Petition for Post-Certification Amendment

Remodel the Site Entrance Gate and Install a Security Guard Shack

Huntington Beach Energy Project
Huntington Beach, California
(12-AFC-02C)

Document No: PPS0714221239SAC

REVISIONS	
CLIENT SUBMITTAL	08/06/2021
P.C.C. #1	09/10/2021
Project Manager:	TT
Date:	10/7/2021
Scale:	
Project Number:	210304
SHEET NUMBER	
C04

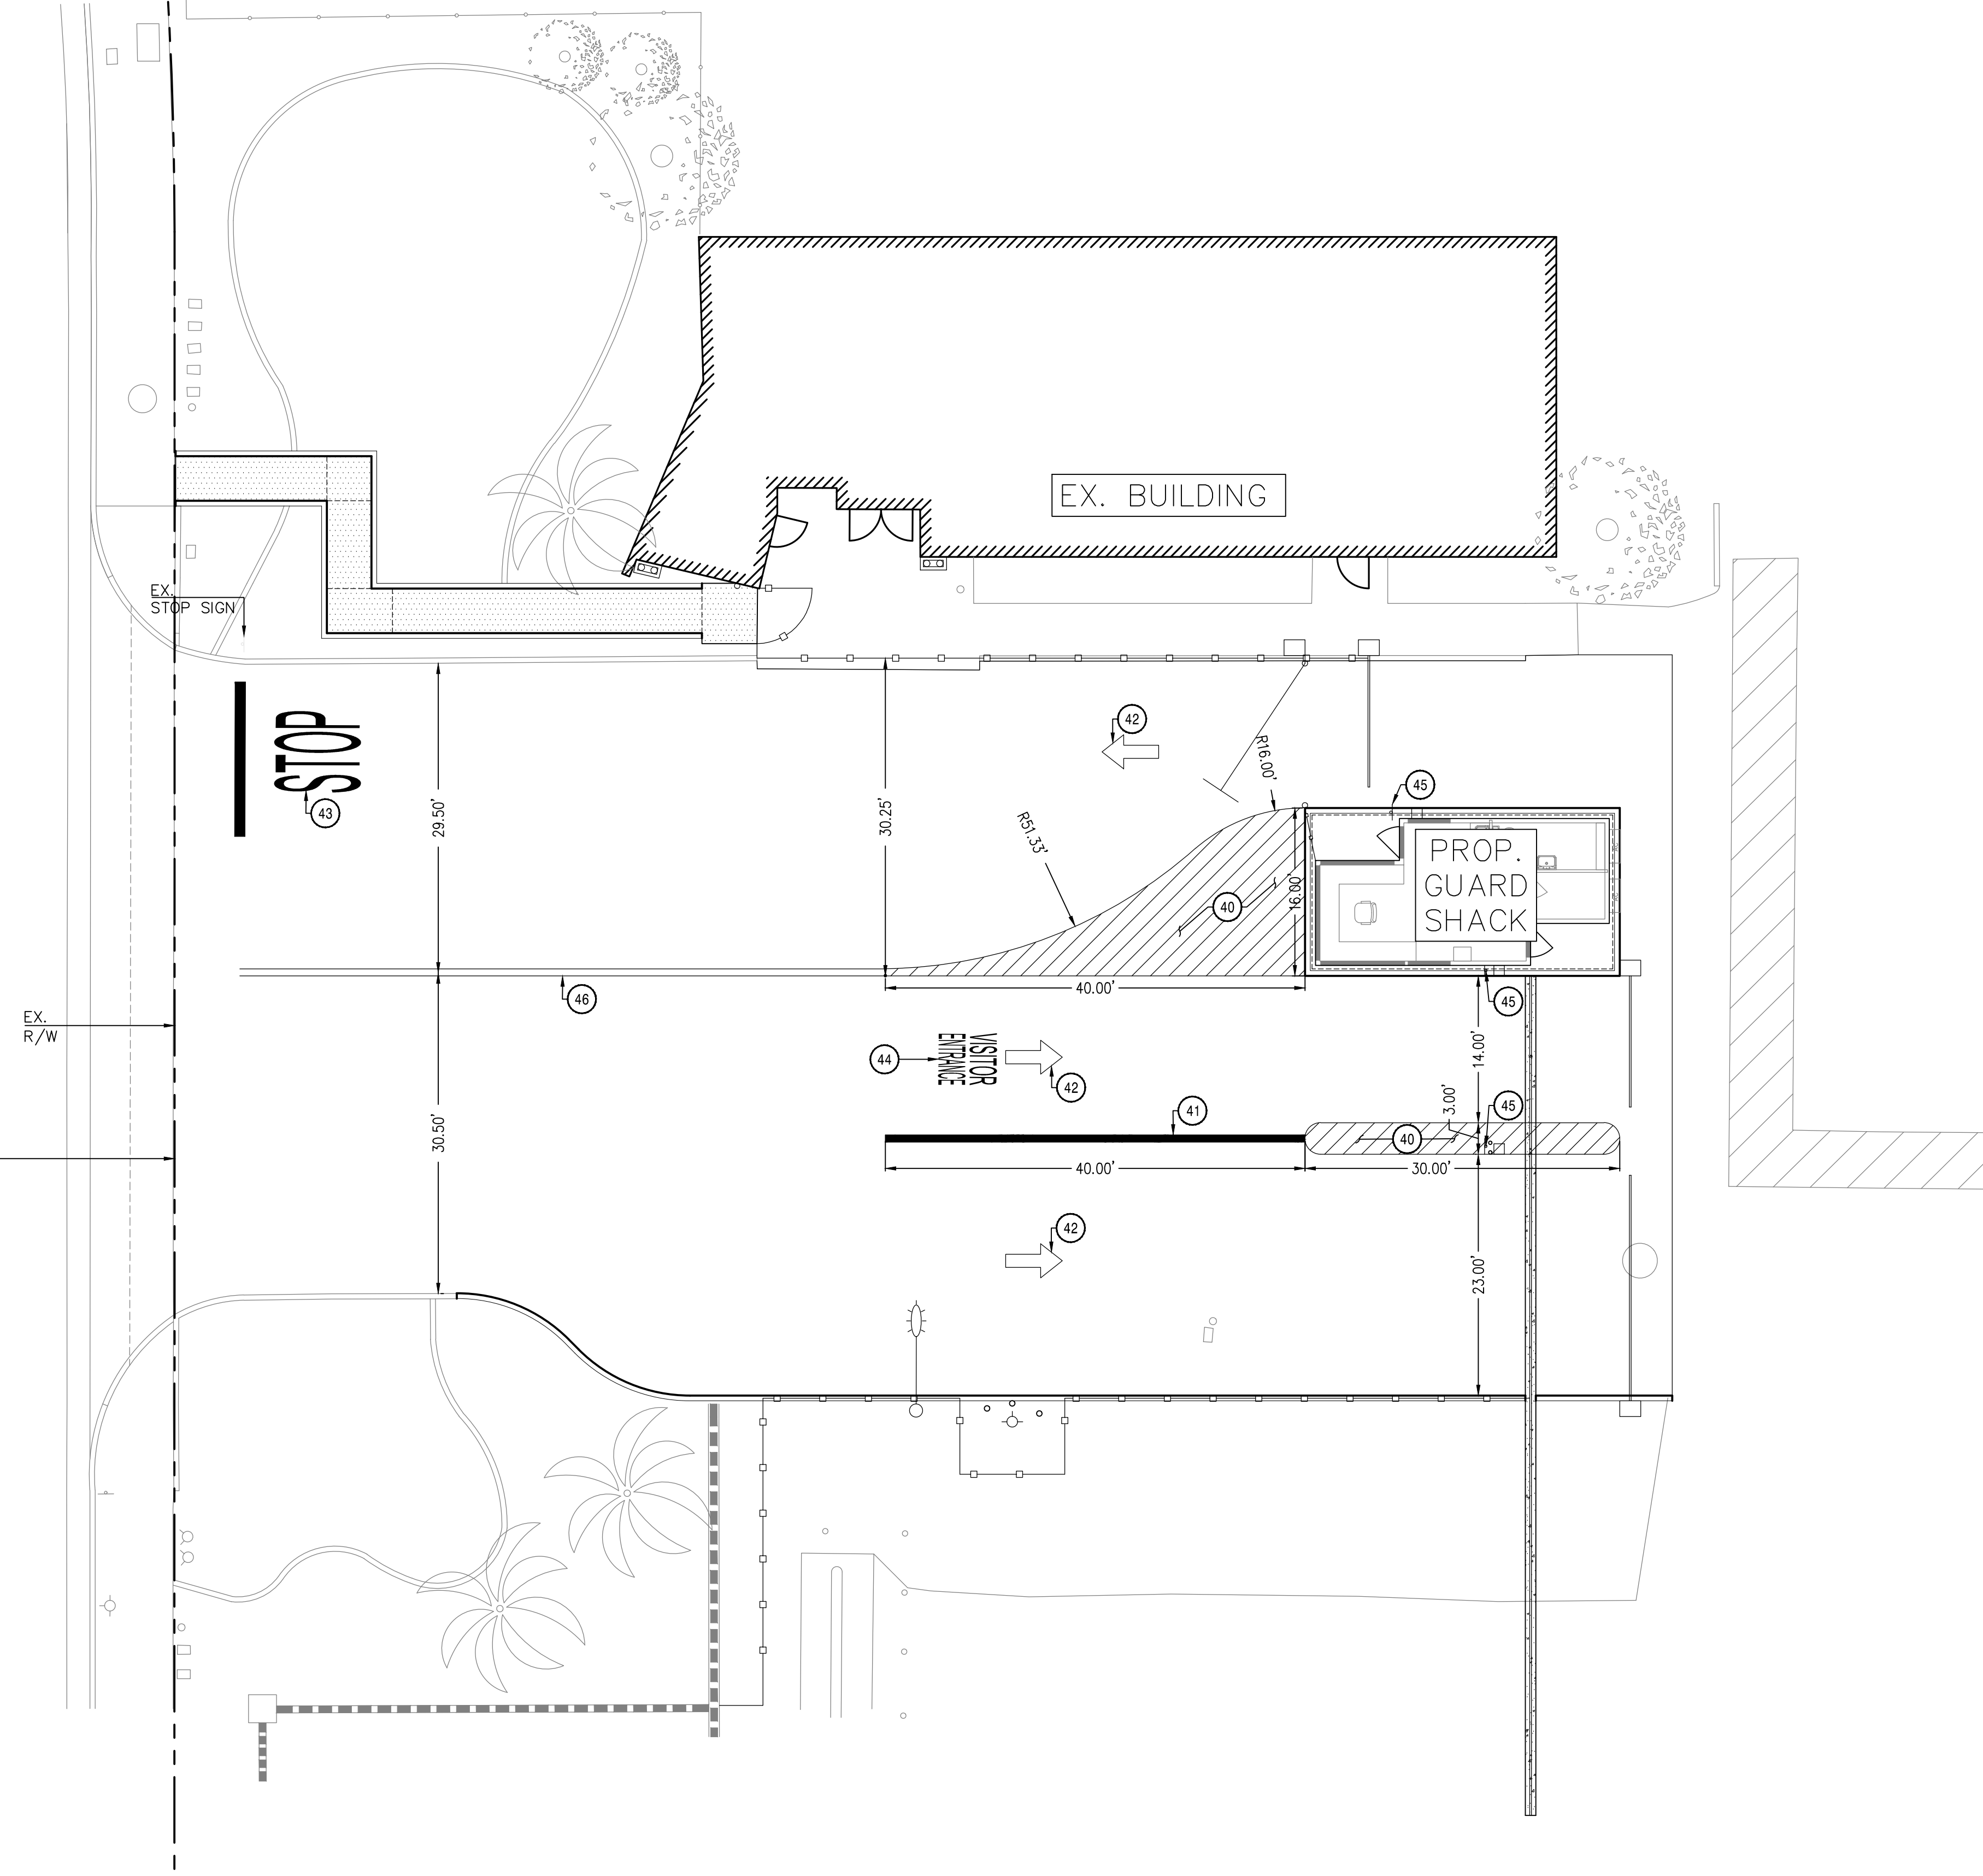
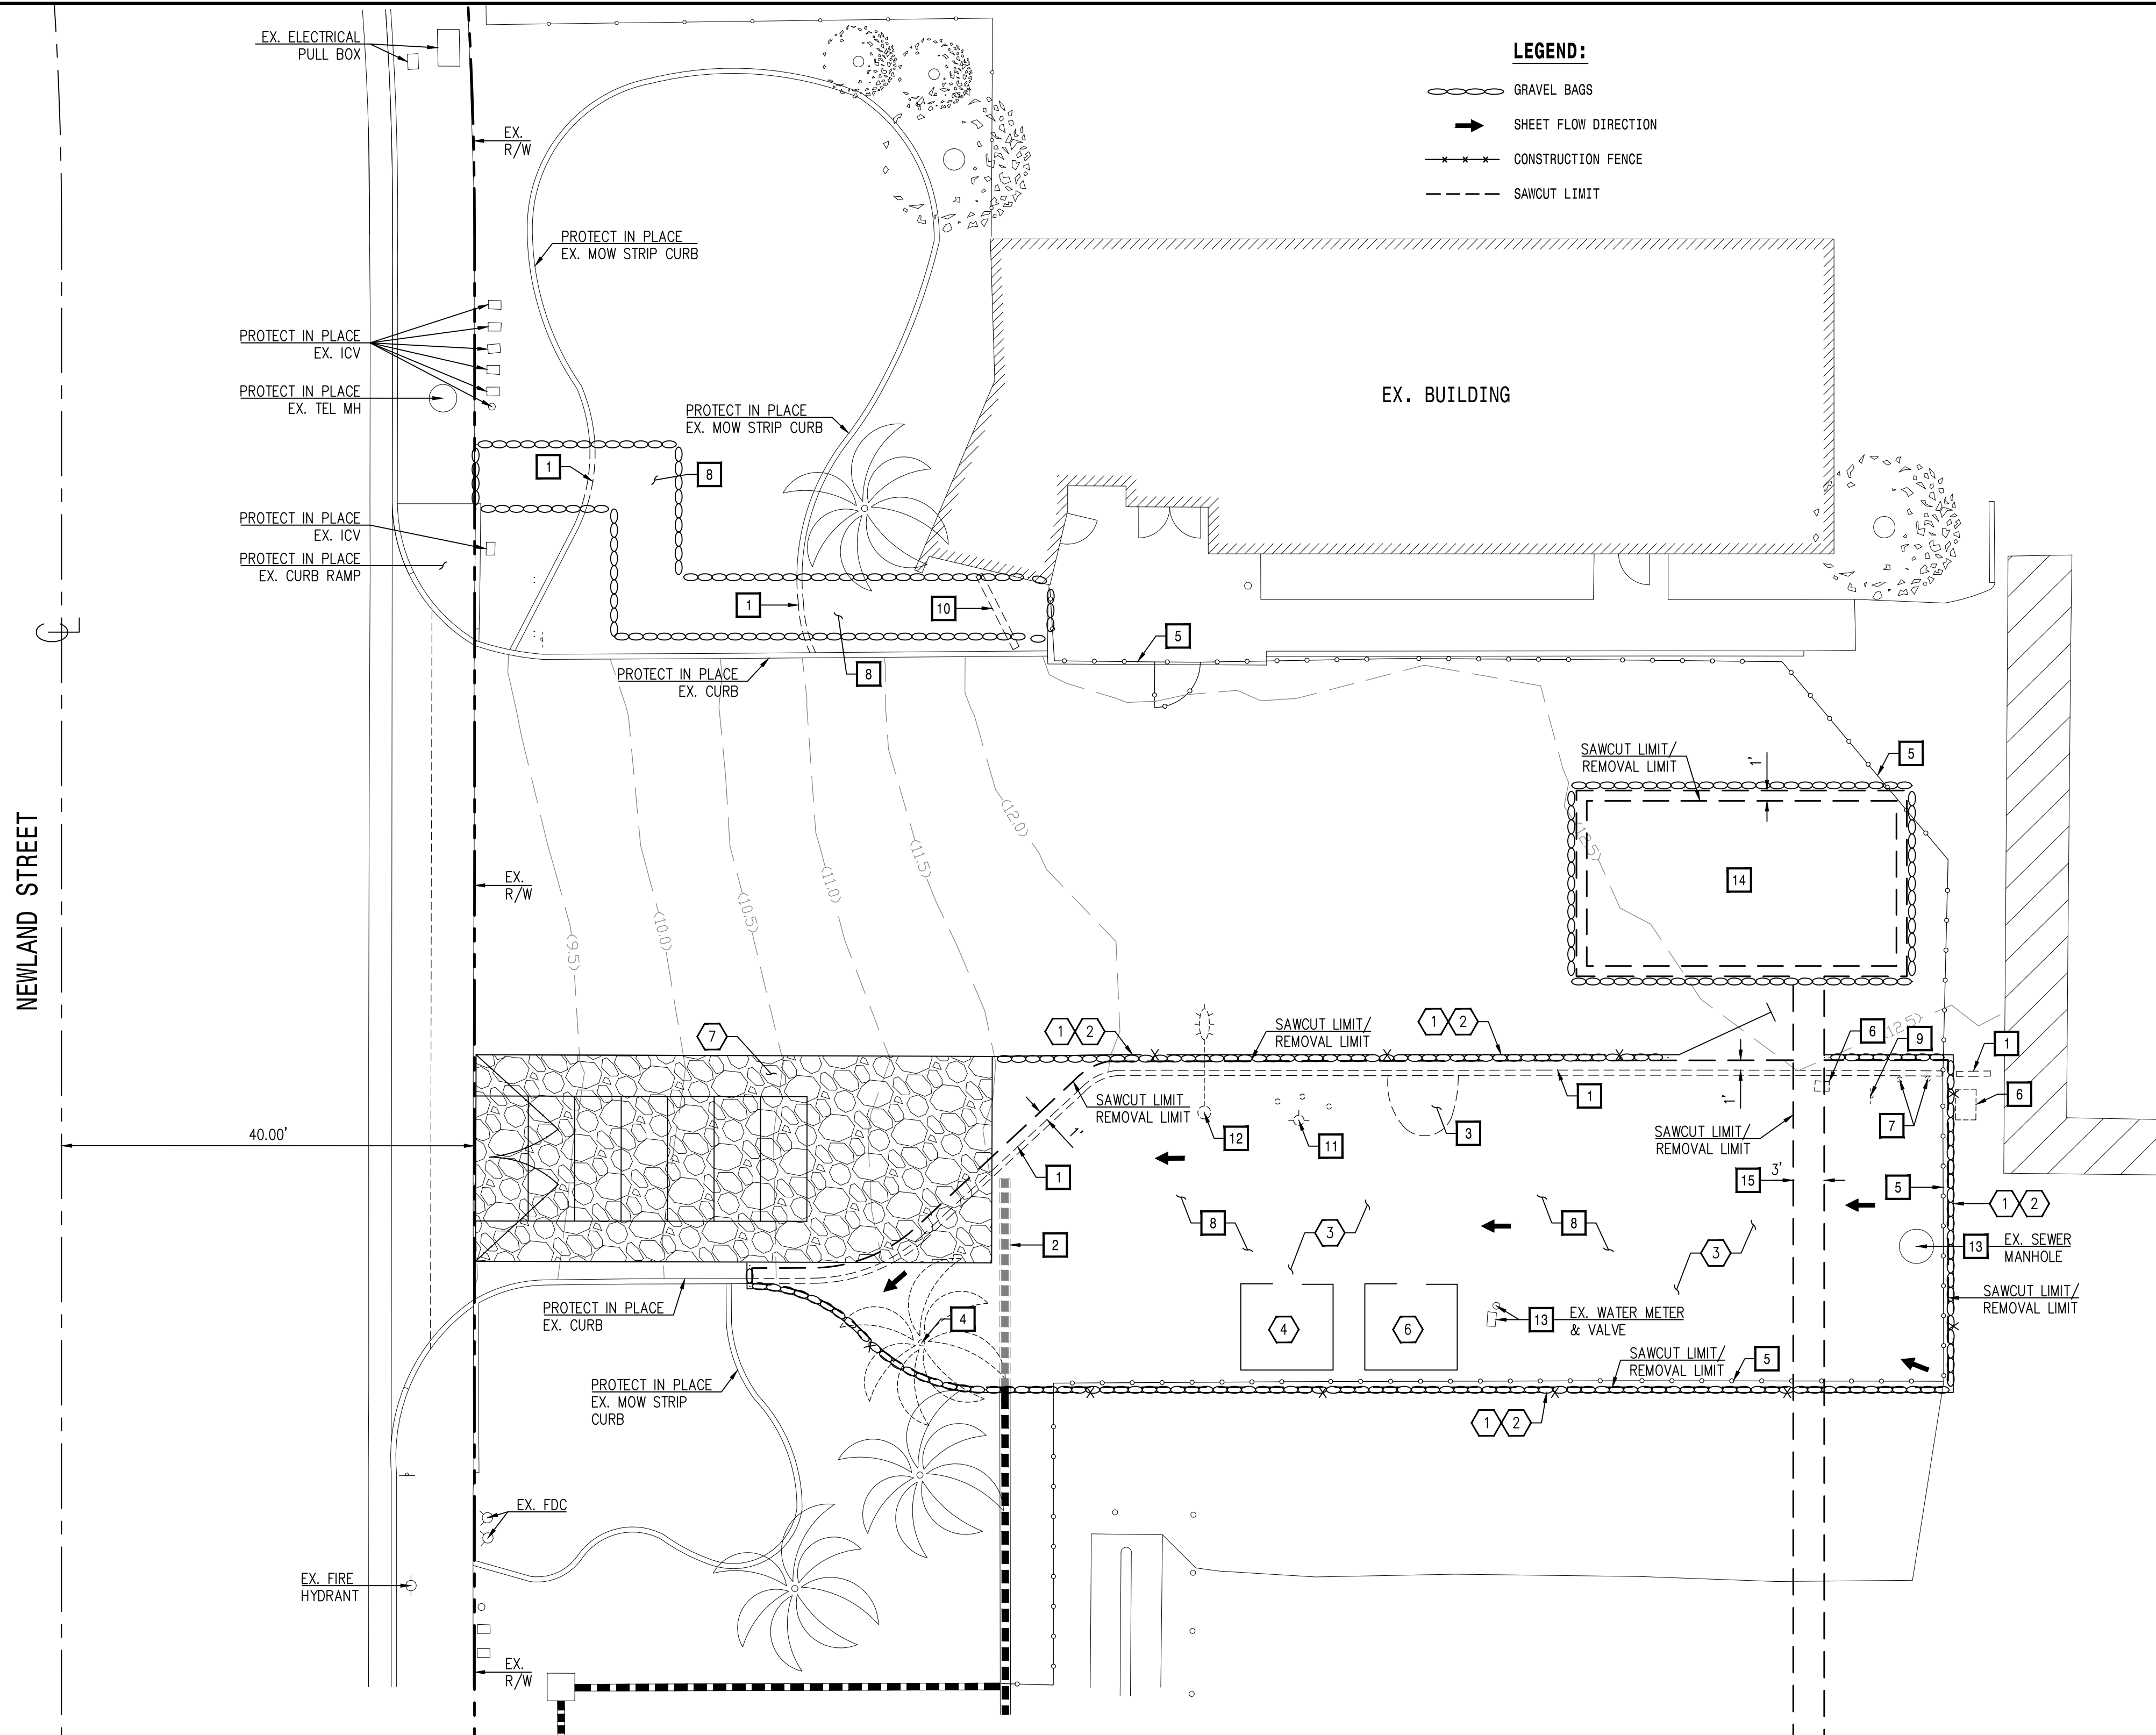
- DEMOLITION NOTES**
- REMOVE AND DISPOSE OF EXISTING CURB
 - REMOVE AND DISPOSE OF PORTION OF EXISTING WALL
 - REMOVE AND DISPOSE OF EXISTING CONCRETE
 - REMOVE AND DISPOSE OF EXISTING TREE

- REMOVE AND DISPOSE OF EXISTING FENCE. CONTRACTOR TO COORDINATE WITH OWNER ON EXISTING FENCE REMOVAL
 - REMOVE AND DISPOSE OF EXISTING ELECTRICAL BOX
 - REMOVE AND DISPOSE OF EXISTING BOLLARD

- REMOVE AND DISPOSE OF EXISTING LANDSCAPE/DIRT
 - RELOCATE EXISTING STOP SIGN
 - RELOCATE EXISTING ENTRANCE SIGN
 - RELOCATE EXISTING FIRE HYDRANT & BOLLARDS

- REMOVE AND DISPOSE OFFSITE EXISTING STREET LIGHT
 - PROTECT IN PLACE AND ADJUST TO GRADE ITEM AS NOTED
 - REMOVE AND DISPOSE OFFSITE EXISTING AC PAVEMENT FOR PROPOSED GUARD SHACK. CONTRACTOR TO FIELD VERIFY LOCATION

- REMOVE AND DISPOSE OFFSITE EXISTING AC PAVEMENT FOR PROPOSED SLIDING GATE CONCRETE PAD. CONTRACTOR TO FIELD VERIFY LOCATION
- EROSION CONTROL NOTES**
